SERVICE BULLETIN

ENGINE - FUEL AND CONTROL - FUEL AND CONTROL - INTRODUCE A REVISED ELECTRICAL CONNECTOR
COOLING SHIELD BRACKET - CATEGORY CODE 4 - MOD.ENG-73-0008

V2500-ENG-73-0008

Modification of air deflector bracket
Fig.1

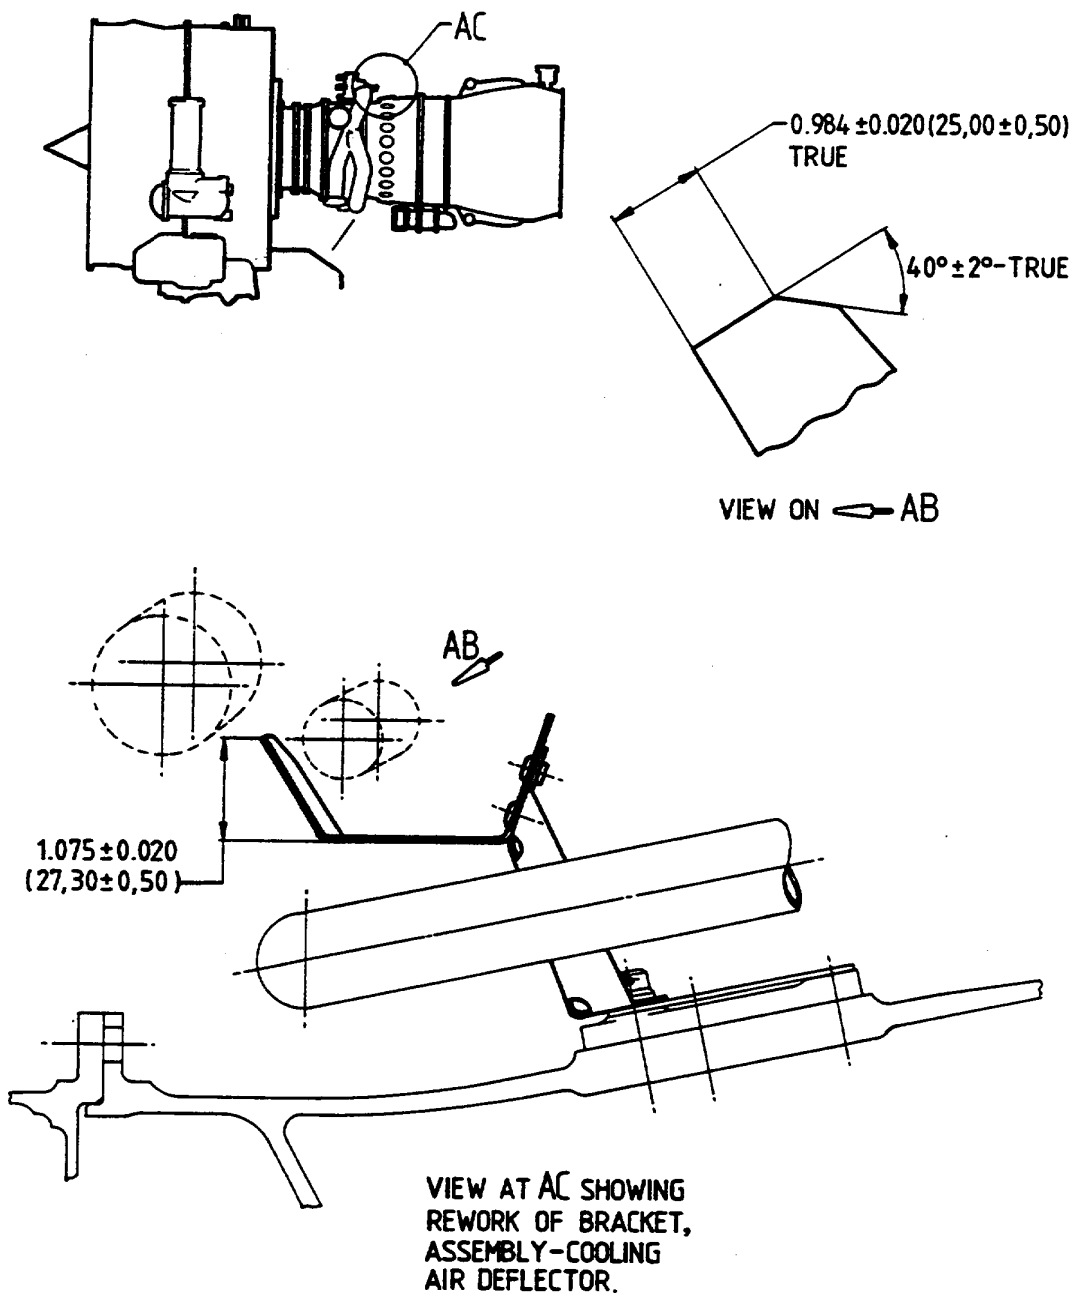
The existing air deflector bracket fitted to deflect the cooling air onto the 7/10th stages cabin air valve electrical connector, could foul the servo pipe which feeds the cabin air valve, also the upper edge of this bracket may not provide sufficient clearance with the valve body.

(A) A modified air deflector bracket is introduced with the upper edge reduced in height by 0.078in. (2,00 mm) and includes a chamfer on the adjacent upper corner.

(4) Existing air deflector brackets can be reworked see fig 1.

Procedure	Supplementary Information	
(a) Mark out area to be removed	Refer to Fig 1	
(b) Remove the material to the 1.075 +/- 0.020in. dimension (27,30 +/- 0,5 mm)	Use hand tools	
(c) Produce the chamfer at 40 degrees true to the surface	Use hand tools	
(d) Remove the sharp edges and the burrs	Use hand tools	
(e) Crack test the bracket	SPM TASK 70-23-01-230-501	
(f) Re-number adjacent to the existing part number	Old Part Number	New Part Number
	6A3996	6A4115
